City of Portland, Maine – Building or Use Permit Application 389 Congress Street, 04101, Tel: (207) 874-8703, FAX: 874-8716

BUILDING PERMIT REPORT

**CITY OF PORTLAND, ME
BOCA 1996 Plan Review Record
One and Two Family Dwelling**

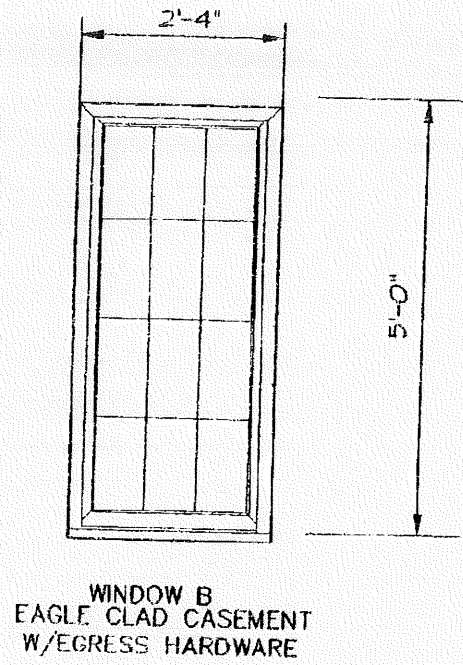
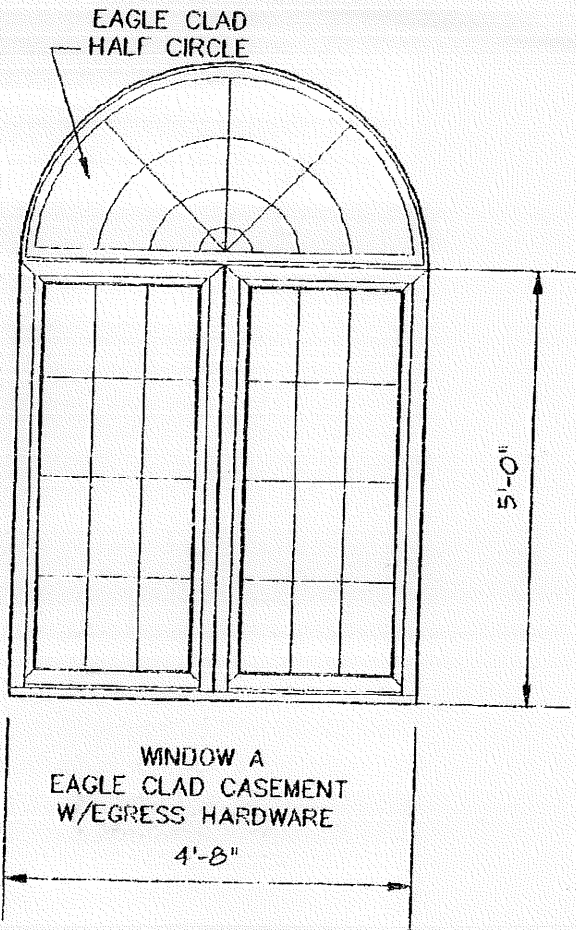
The sleeping rooms as shown on the floor plan do not meet the emergency escape & rescue provisions missing required egress sized (5.7 sq. ft.) and the garage stairs and rear deck do not have required guards.

As you requested, you will find drawing of proposed window changes to correct existing code violations at my new home at 55 Penrith Rd., Portland, Me.

On the second floor bedrooms we propose to replace existing double hung windows with Eagle clad casement w/ Egress hardware.
